Exhibit B

Recommended Amendments to the 2015 International Residential Code North Central Texas Council of Governments Region

Figure R602.6.1; delete the figure and insert the following figure:

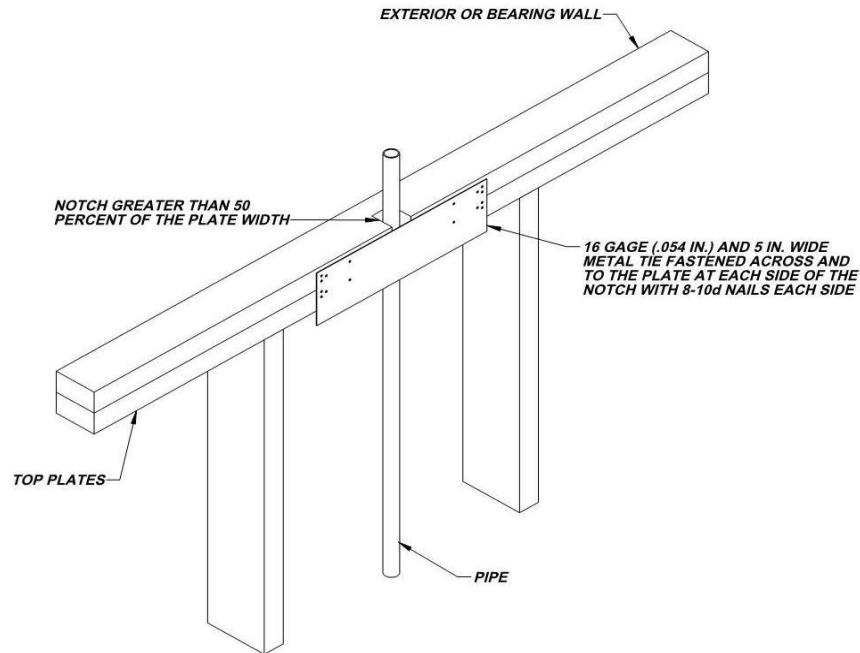
R602.6.1 Drilling and notching of top plate. When piping or ductwork is placed in or partly in an exterior wall or interior load-bearing wall, necessitating cutting, drilling or notching of the top plate by more than 50 percent of its width, a galvanized metal tie not less than 0.054 inch thick (1.37 mm) (16 Ga) and 5 inches (127 mm) wide shall be fastened across and to the plate at each side of the opening with not less than

eight 10d (0.148 inch diameter) having a minimum length of 1 ½ inches (38 mm) at each side or equivalent. Fasteners will be offset to prevent splitting of the top plate material. The metal tie must extend a minimum of 6 inches past the opening. See figure R602.6.1. *{remainder unchanged}*
